755 - TC 9:30 am - NW Bikeways Project

Reference: ESCO Comments on Northwest Bikeways
Project--Vaughn Wardway 24th to Nicolai

ESCO Corporation ("ESCO") is opposed to the Northwest Vaughn/Wardway Project and asks that it be stricken from the Northwest Bikeways Project list at this time.

NW Vaughn

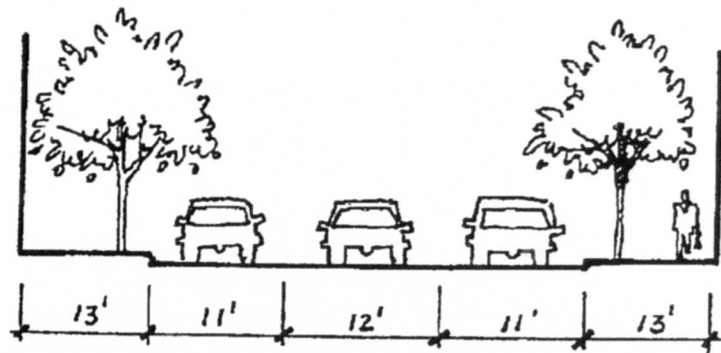
Second, committing two five-foot bike lanes and a parking strip requires a narrowing of the travel lanes and loss of the center left-turn/refuge lane. This arrangement is not acceptable because of the increased congestion caused by loss of the left-turn refuge. Further, narrowing the travel lanes from 12 feet increases hazards from trucks and pushes the limits of the AASTHO standards for truck lanes.

It is a significant hardship to have bike lanes on Vaughn at this time. Where constraints exist, a parallel bikeway within one-quarter mile is acceptable according to the Design and Engineering Guidelines of the Bicycle Master Plan (see note, page A2). Thurman serves as an excellent connection for bikes between 23rd and St. Helens Road. Thus, Vaughn's constraints point to Thurman as a proper place for bike lanes. Rather than the proposal, ESCO favors the design for Vaughn shown in the enclosed section for the 24th to the 27th area.

NW Vaughn Proposed Configuration (24th to 27th)

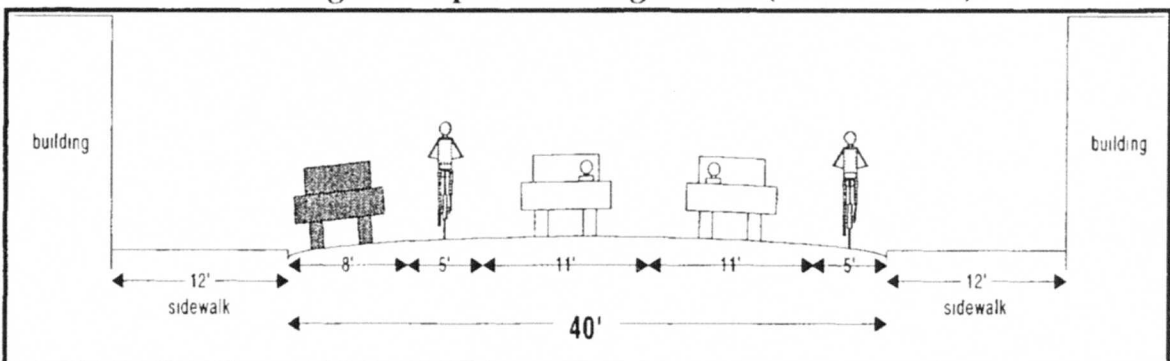
A planned development at 28th Place and Wardway will create a driveway onto Wardway and a 2-foot center median to prevent left turns into or out of the development. Because this median will provide 16 feet of lane width in each of the

two travel lanes on Wardway, accommodating a bicycle lane will not be hindered

The development will have access to and egress from Wardway. A 2-foot center median will be constructed so vehicles entering or exiting the development can turn right, only. The width of the divider will not interfere with our plans to provide a bike lane.
